## Final Product/Process Change Notification

Document #:FPCN24563XC

<b>Title of Change:</b>	UTAC Thai Limited Assembly site expansion for non-automotive.
<b>Proposed First Ship date:</b>	06 Oct 2022 or earlier if approved by customer
<b>Contact Information:</b>	Contact your local onsemi Sales Office or <a href="mailto:Naruedol.Srisamran@onsemi.com">Naruedol.Srisamran@onsemi.com</a>
<b>PCN Samples Contact:</b>	Contact your local onsemi Sales Office. Sample requests are to be submitted no later than 30 days from the date of first notification, Initial PCN or Final PCN, for this change. Samples delivery timing will be subject to request date, sample quantity and special customer packing/label requirements.
<b>Additional Reliability Data:</b>	Contact your local onsemi Sales Office or <a href="mailto:Shiela.Crosby@onsemi.com">Shiela.Crosby@onsemi.com</a>
<b>Type of Notification:</b>	This is a Final Product/Process Change Notification (FPCN) sent to customers. FPCNs are issued 90 days prior to implementation of the change. onsemi will consider this change accepted, unless an inquiry is made in writing within 30 days of delivery of this notice. To do so, contact <a href="mailto:PCN.Supp

Illustration of case outline showing the exposed pad dimensions D2 and E2

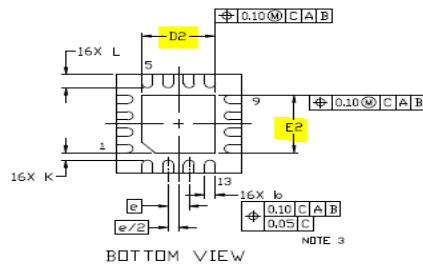
Add UTAC Thailand Bangsamak site as alternative assembly site by apply same machine model and same material. Including update in case outline dimensions D2 and E2 tolerances for the exposed pad have increased by 0.10 mm. This does not affect the Recommended Mounting Footprint shown on the case outline drawing

Before Change Description	After Change Description
Assembly Site	UTAC Thailand Bangkok site	UTAC Thailand Bangkok site (site1) and UTAC Thailand Bangsamak site (Site3)
Case Outline Dimensions D2 & E2	See illustration below for D2 and E2 dimensions.	
	Dimension	Before (MIN, NOM, MAX) mm
	D2	1.70, 1.75, 1.80
	E2	1.70, 1.75, 1.80
	See illustration below for D2 and E2 dimensions.	
	Dimension	After (MIN, NOM, MAX) mm
	D2	1.65, 1.75, 1.85
	E2	1.65, 1.75, 1.85
